December 5, 2013

Broadstone West Seattle
Design Review Board Recommendation Packet

4745 40th Ave SW Seattle WA

Wide Planter Strip Locations

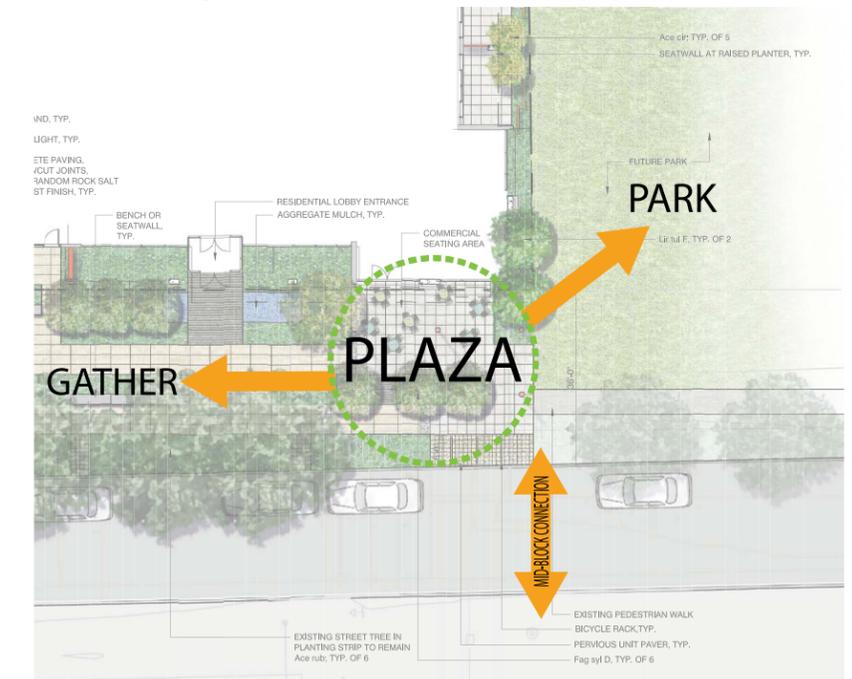
1st EDG Meeting: Evidence of how the proposal connects with other projects (namely the Whole Foods site) across 40th Ave. SW needs further explication. Provide a schematic or concept landscape plan along the frontage for the next EDG meeting. The wide planting strip on 40th Ave SW warrants a creative landscape design that complements the design for the Whole Foods mixed use project.

2nd EDG Meeting: The Board endorses the landscape concept along 40th Ave SW, in particular, the manner in which the design changes in response to the adjacent uses. As the design evolves, the lighting design should enhance the tripartite scheme.

The pedestrian nature of 40th Ave is enhanced in the proposed design. The plaza landscaping in front of the Whole Foods Project is emulated in the design of the wide planter strip in front of the project, while acknowledging the transition from the larger commercial scale to the north, and the smaller residential scale to the south. The change in scale is reflected in the proposed design that transitions from larger plaza spaces at the northern corner, to smaller gathering spaces in front of the live/work units.

The entry plaza to the project creates a connector between the future park and the landscaped planting and gathering space to the south.

Additional landscape elements further emphasize the transition between the large scale commercial and the smaller scale residential south of Edmunds.

Courtyard - Open Space Relationship

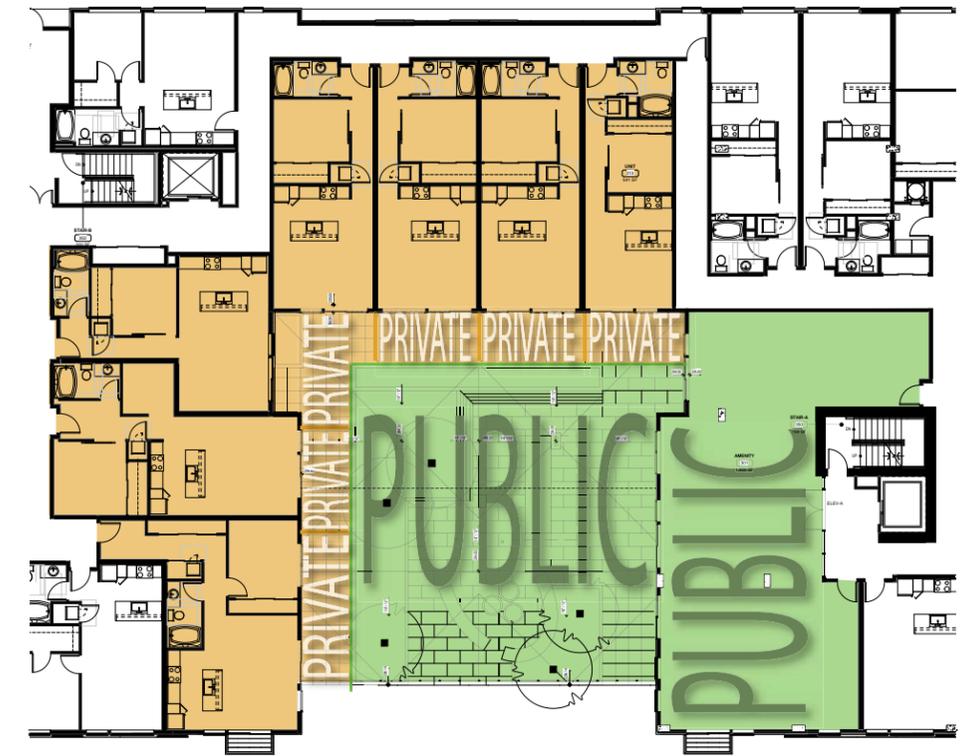
1st EDG Meeting: Provide a conceptual landscape plan by the next meeting. Focus the effort on open spaces adjacent to the future park, at the broad planting strip on 40th Ave SW and on the upper level open space.

2nd EDG Meeting: Fences separating dwelling units from the future park should obscure a person when sitting on his or her patio but allow for visibility when standing. Fences should approximate a height of four feet.

A hierarchy of open spaces is provided. The public planter strip is landscaped to enhance activity and is edged with transitional planters to increase privacy and create opportunities for interaction. The upper level courtyard is accessed through common amenity space to a gathering place ringed with private patios. Fences separating dwelling units from the future park project are incorporated into the design. Per recommendations from the Parks Department, the fences are opaque to a height of 4', with semi-transparent screening to a height of 6'.

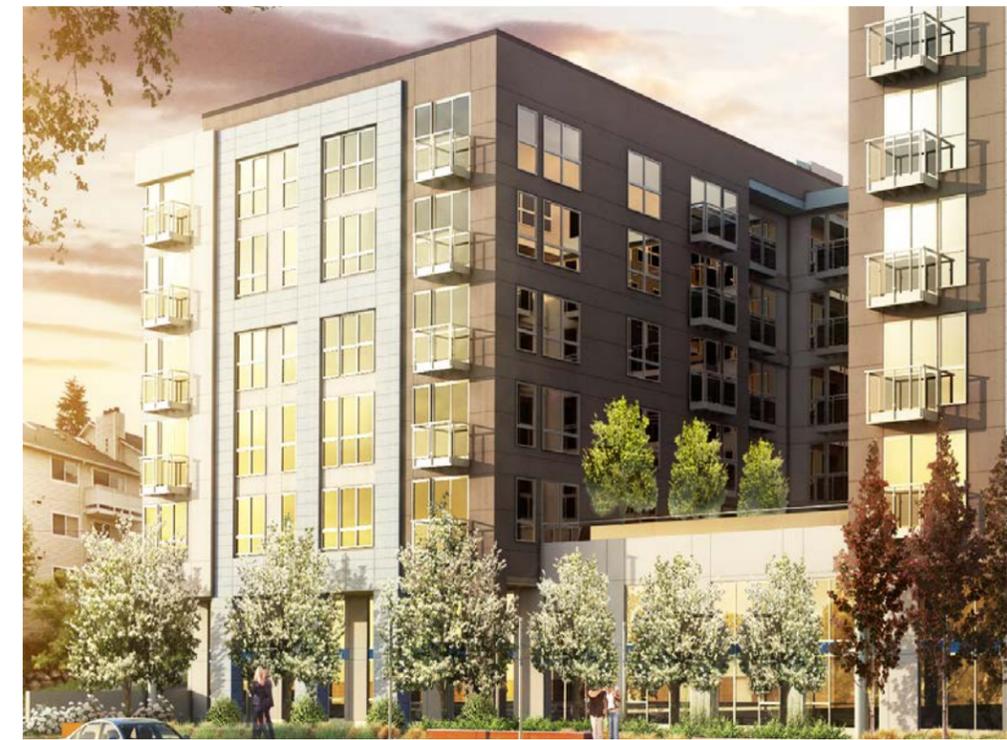
1st EDG Meeting: The Board, reinterpreting the guideline, noted the significance of the building's corner at the future park and 40th Ave SW. The structure's corner should have a prominence more significant than the corner at Edmund's St.

The importance of the corner is highlighted by extensive glazing, decks and facade articulation. The commercial space engages the street to create a visually prominent corner at a distance and at the pedestrian scale. Outdoor spill-out seating is provided for the commercial space adjacent to the park to provide activity and ground plane continuation of public uses.

West Building Elevation - Overall Rhythm of Scale

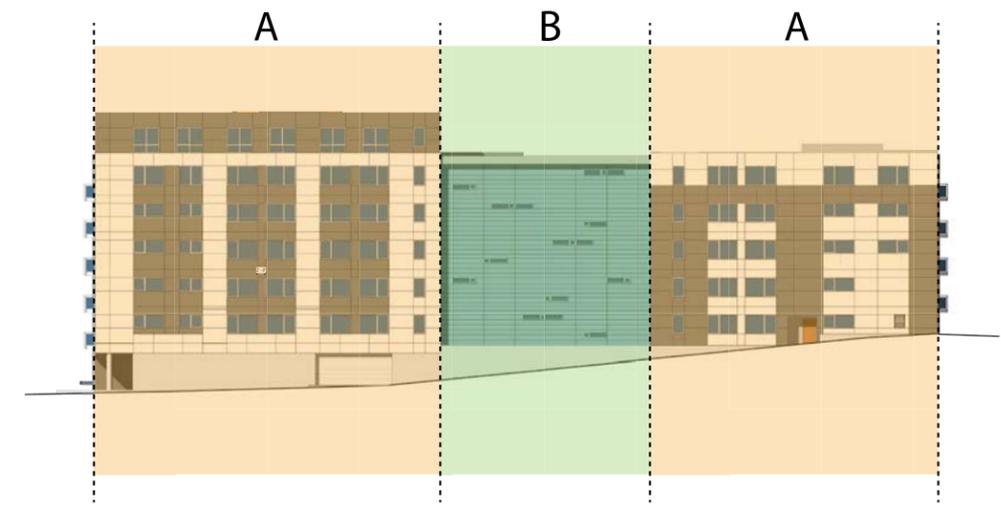
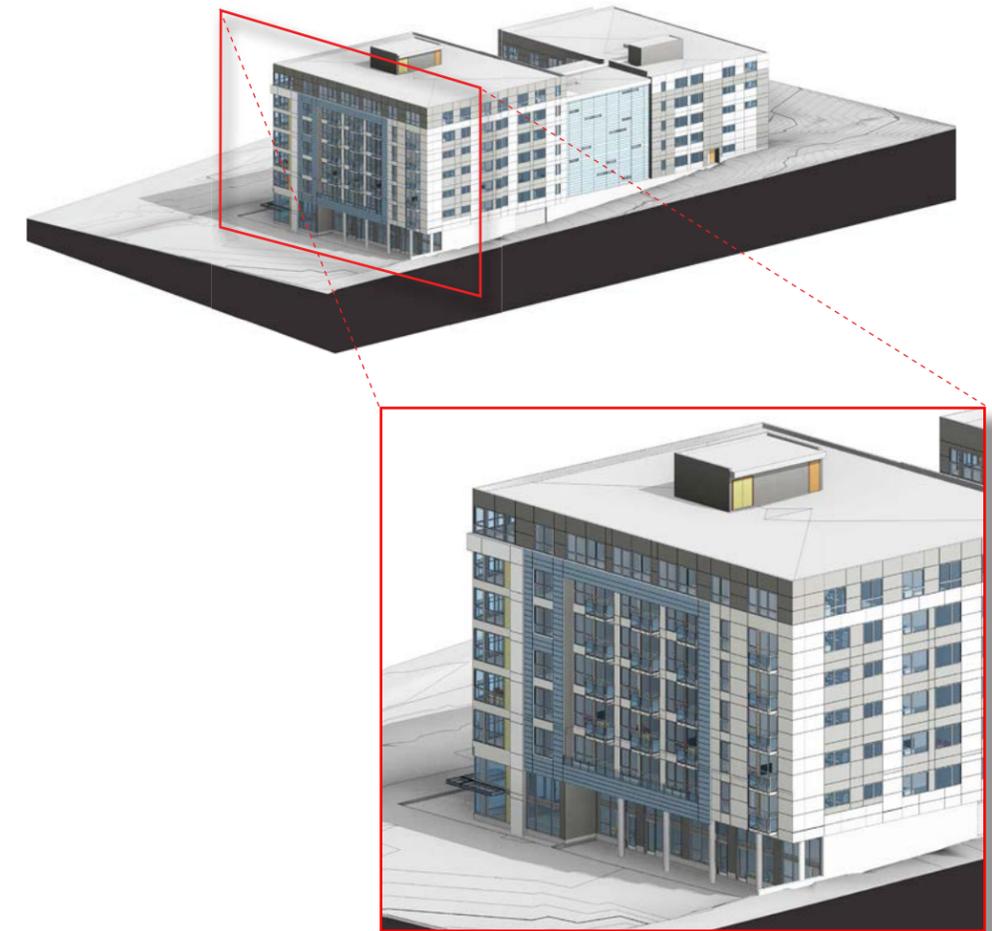
1st EDG Meeting: The Board noted the proposal's lack of recognition of the residential structures across the alley. The architect should step the structure back from the alley or sculpt its west facade in deference to the neighboring structures.

None of the three design alternatives received the Board's endorsement. A revised design may result in a hybrid of the three. Along with changes to the west facade, the structure should exhibit modulations or changes in form on the north facade facing the park. A sheer vertical elevation facing the park is unwelcome. The south facade ought to acknowledge the incline along Edmunds St. and respond to the grades at the street frontage. The varying heights of the wings, the extent of the plinth and the size and placement of the second floor open space received lengthy Board deliberation. No explicit direction emanated from the discussion; however, elements of schemes B and C had merit.

The proposed project creates a transition between the higher zoning to the north and the smaller scale pattern to the south. While the project zoning is higher than the zoning to the west, the proposed design is lower than the allowable zoning height to relate to the neighboring projects. The massing of the project is broken into three structures to relate in scale to the projects to the west. Modulation has been added on the west and north elevations to create interest and scale. Specifically, on the west elevation, a similar language of fenestration and rhythmic bays to the rest of the buildings envelope is portrayed through variation in color. This technique will effectively create interest while the use of both light and dark colors will create a balanced effect on natural light reflection for the neighboring structures.

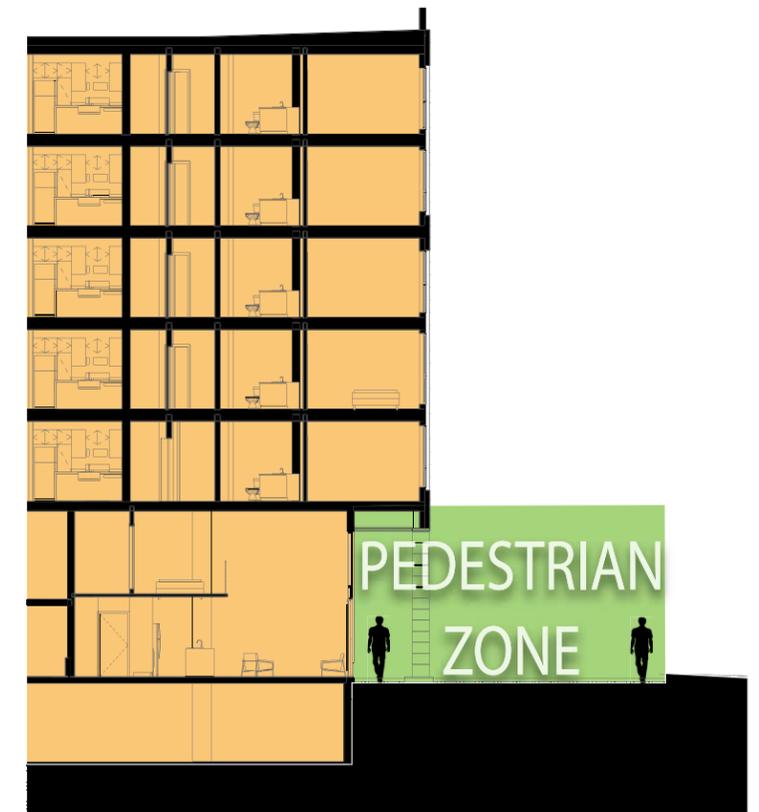
1st EDG Meeting: By the next EDG meeting, the design team must present a strong concept plan for the landscaping along 40th Ave SW and other open spaces. Scale and size the open spaces to orient to the neighborhood and future developments.

2nd EDG Meeting: The Board notes its satisfaction with the initial efforts illustrated in the 40th Ave SW concept landscape plan.

The landscape zone is designed to enhance activity, and the adjacent patios create transitions and interest at the pedestrian level. The ground floor is set back to enhance the pedestrian experience and create transition zones. The scale of the pedestrian experience grows from the south to the north to connect the residential neighborhood to the park and the commercial zone to the north.

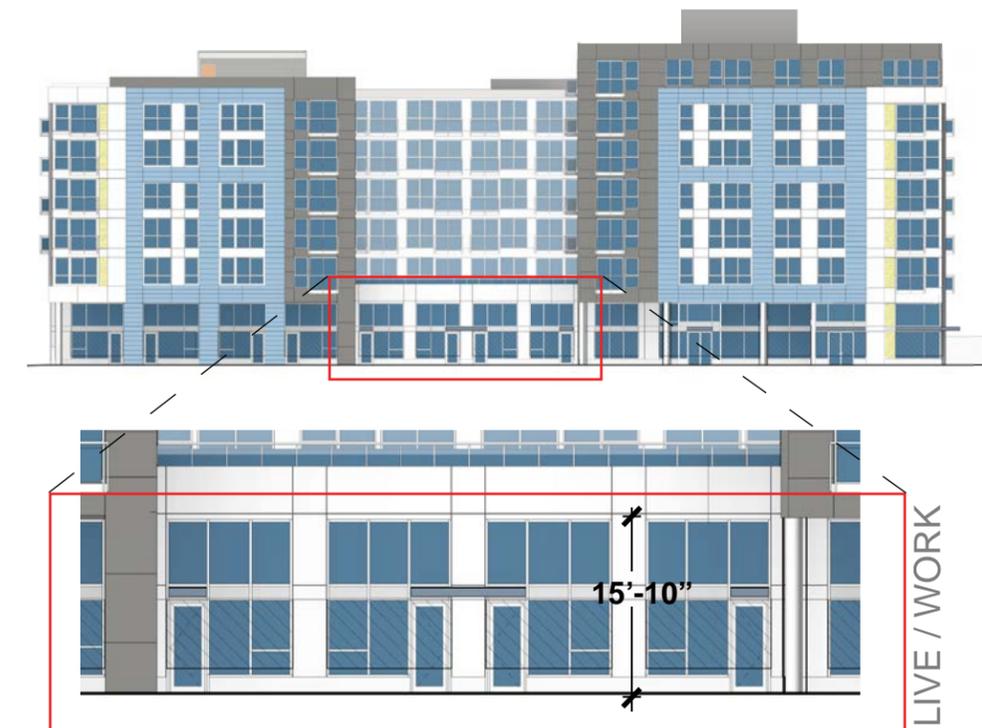
1st EDG Meeting: Ensure that live/work spaces have expansive amounts of glazing at the street frontages.

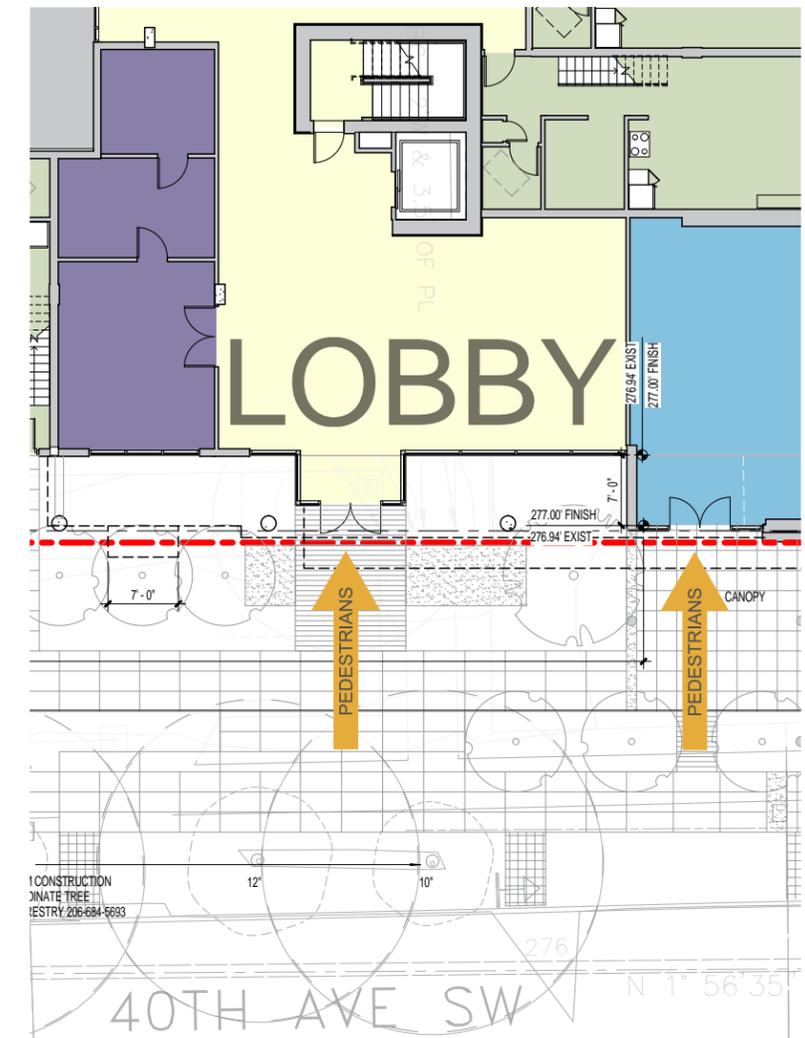
1st EDG Meeting: The future park provides a special opportunity for this project. Without the city's design for the future park to the north, however, the landscape architect has little direction in which to create a complementary outdoor space. Design for both continuity and the privacy of residences facing park.

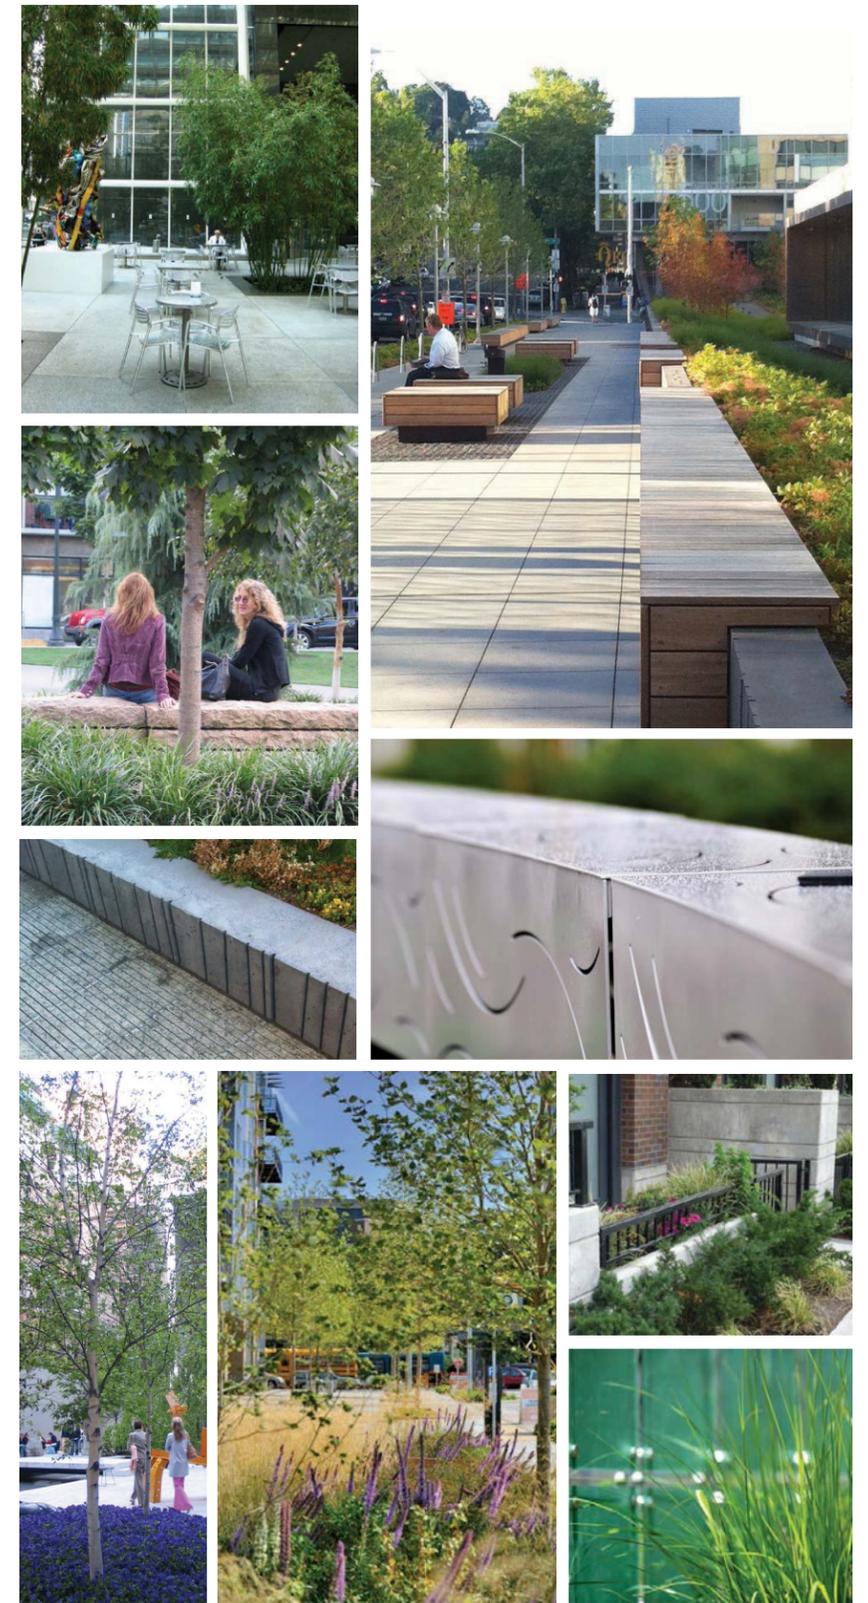
1st EDG Meeting: Provide a schematic landscape plan for the street frontages, the area adjacent to the park land, and the upper level open spaces.

Landscaping is proposed to enhance the public realm along the street, provide transitional spaces, and incorporate an appropriate edge along the future park. The upper level terrace will provide outdoor amenity space for all of the buildings occupants while also providing private patio spaces for the adjacent units. Continuity of landscape elements will draw relationships to the ground level site treatment. See response to A-7.
